# UNITED STATES PATENT AND TRADEMARK OFFICE

APPLICATION NO.	FILING DATE	FIRST NAMED INVENTOR	ATTORNEY DOCKET NO.	CONFIRMATION NO.
10/674,704	09/30/2003	Tony A. Opheim	42.P16903	4545

<b>Office Action Summary</b>	<b>Application No.</b> 10/674,704	<b>Applicant(s)</b> OPHEIM, TONY A.	
	<b>Examiner</b> Leonardo Andújar	<b>Art Unit</b> 2826

## **DETAILED ACTION**

Fig. 6

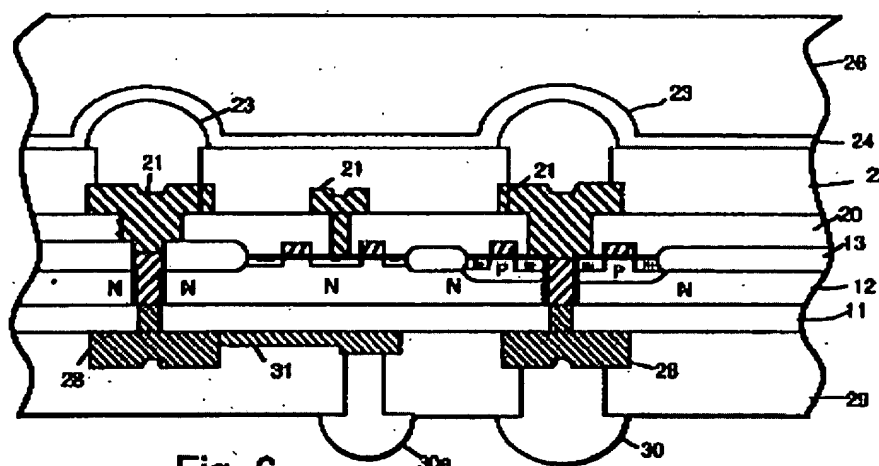
6. Regarding claim 1, Finnila (e.g. figs. 6) shows a die comprising: a dielectric layer 20/13 positioned on top of a semiconductor support layer 11/12; a via passing through the dielectric layer and the semiconductor support layer, wherein a first end of the via is positioned in the dielectric layer and a second end of the via is positioned in the semiconductor support layer, wherein a first diameter of the first end is greater than a second diameter of the second end; and a contact 21 positioned on top of the dielectric layer, the contact coupled to the first end of the via, wherein the contact to be coupled to a device of the die (e.g. transistor).

7. Regarding claim 7, Finnila shows that the via includes a metal filled via (col. 4/ll.

12. Regarding claims 20 and 24, Finnila (e.g. figs. 6) shows a die package or a processor (col. 7/ll. 46), comprising: a semiconductor support layer 11/12; a dielectric layer 20/13 disposed on the semiconductor support layer; a via including a first end and a second end, the first end positioned the dielectric layer and the second end positioned in the semiconductor support layer, wherein a diameter of the first end is greater than a diameter of the second end; a first contact 21, disposed on the dielectric layer, coupled to the first end of the via, wherein the first contact coupled to a device of the die package (e.g. transistor); and a second contact 30, disposed on the semiconductor

support layer, coupled to the second end of the via. Finnila does not show that the second contact is mounted a printed circuit board. Nevertheless, Grainger (e.g. fig. 4 and 3) shows a second contact 20 mounted on a printed circuit board 17. It would have been obvious to one of ordinary skill in the art at the time the invention was made to mount the second contact disclosed by Finnila on a printed circuit board in accordance with Grainger's invention to provide support, an interconnection means as well as a heat dissipation means.

13. Regarding claim 27, Finnila shows that the first diameter is twice the second diameter.

**Fig. 2D**

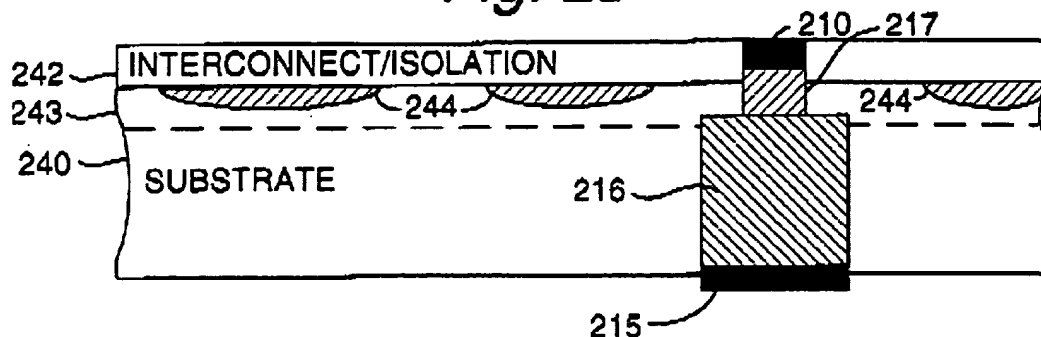
9. Claims 2 is rejected under 35 U.S.C. 103(a) as being unpatentable over Finnila (US 5,426,072) in view of Hsuan (US 6,429,509).
10. Regarding claim 2, Finnila shows most aspects of the instant invention except for a shaft between the first end and the second end wherein the shaft has a diameter similar to the second diameter. Nevertheless, Hsuan (e.g. fig. 2D) a via including a shaft between a first end 216 and the second end 217 wherein the shaft has a diameter similar to the second diameter.

According to Hsuan, this type of interconnection minimizes the I/O signal attenuation, inductance and capacitance of integrated circuit (col. 3/lls. 42-45). It would have been obvious to one of ordinary skill in the art at the time the invention was made to make the vias disclosed by Finnila having a shaft between the first end and the second end wherein the shaft has a diameter similar to the second diameter in accordant to Hsuan's invention to minimize the I/O signal attenuation, inductance and capacitance of integrated circuit.

15. Regarding claim 25, Finnila in view of Gnadinger shows most aspects of the instant invention except for a shaft between the first end and the second end wherein the shaft has a diameter similar to the second diameter. Nevertheless, Hsuan (e.g. fig. 2D) shows a via including a shaft between a first end 216 and the second end 217 wherein the shaft has a diameter similar to the second diameter. According to Hsuan, this type of interconnection minimizes the I/O signal attenuation, inductance and capacitance of integrated circuit (col. 3/lls. 42-45). It would have been obvious to one of ordinary skill in the art at the time the invention was made to make the vias disclosed by Finnila having a shaft between the first end and the second end wherein the shaft has a diameter similar to the second diameter in accordant to Hsuan's invention to minimize the I/O signal attenuation, inductance and capacitance of integrated circuit
